Program Bulletin

CUSTOMER SATISFACTION PROGRAM

SUBJECT: Engine Harness Chafing On EGR Stud

MODELS: 2015 Chevrolet Silverado HD
2015 GMC Sierra HD
Equipped with the Duramax Diesel 6.6L Engine (RPO LML)

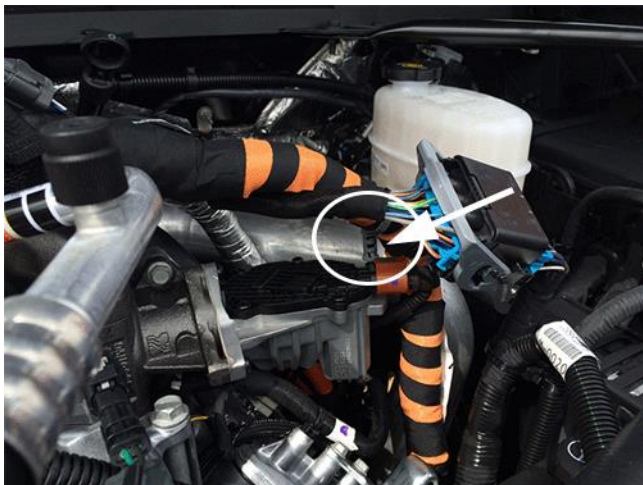
3. Disconnect the X107 (36 way) connector and reroute the male end under the main engine harness (orange flex wrap) and reconnect X107 connector.

4. Locate and install the gray standoff clip onto the EGR stud.
5. Remove fender covers and close hood.
